# Access Compliance Report

## Public Rights-of-Way

### (Curb Ramps)

Intersection ID: 15336	Main Street: E_INDEPENDENCE_BV	Cross Street: WOODLAND_DR	Location: NE
ADA ID: 771609A3E991	Ramp Type: Perp	Initial Pass/Fail: Fail	Overall Compliance: No
Severity Score: 21.25			
Codes/Mitigation Info/Possible Solution		Field Measurements/Component Compliance

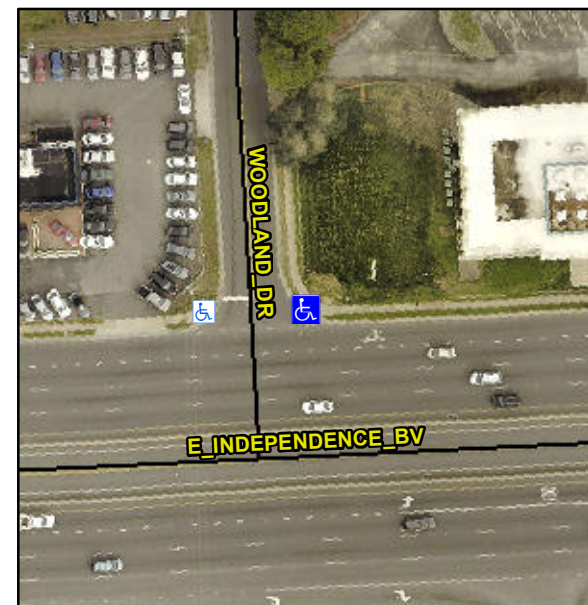
**Remove & Replace Entire Ramp.**

**Not Found, R304.5.1, R304.5.3**

Compliance	Description	Data	Compliance	Description	Data
N/A	Ramp Length (in)	89.0	Yes	Ramp Slope (%)	6.2
No	Ramp Width (in)	43.5	No	Ramp XSlope (%)	5.2
N/A	Flare Type LT	N/A	N/A	Flare Type RT	N/A
N/A	Flare Slope LT (%)	N/A	N/A	Flare Slope RT (%)	N/A
N/A	Flare Traversable LT?	N/A	N/A	Flare Traversable RT?	N/A
N/A	Landing Length (in)	N/A	N/A	DWS Provided?	N/A
N/A	Landing Width (in)	N/A	N/A	DWS Contrast?	N/A
N/A	Landing Slope (%)	N/A	N/A	DWS Length (in)	N/A
N/A	Landing X Slope (%)	N/A	N/A	DWS Full Width?	N/A
N/A	Landing Curb? (Y/N)	N/A	N/A	DWS Offset (in)	N/A
N/A	Shared Landing?	N/A			
N/A	Gutter Ponding?	N/A	N/A	Gutter Slope (%)	N/A
N/A	Gutter Lip Ht (in)	N/A	N/A	Gutter X Slope (%)	N/A
N/A	Painted X Walk1?	No	N/A	Painted X Walk2?	N/A
	X Walk 1 Direction	To W		X Walk 2 Direction	N/A
N/A	X Walk 1 Width (in)	N/A	N/A	X Walk 2 Width (in)	N/A
	X Walk 1 Slope (%)	4.6		X Walk 2 Slope (%)	N/A
	X Walk 1 X Slope (%)	4.1		X Walk 2 X Slope (%)	N/A
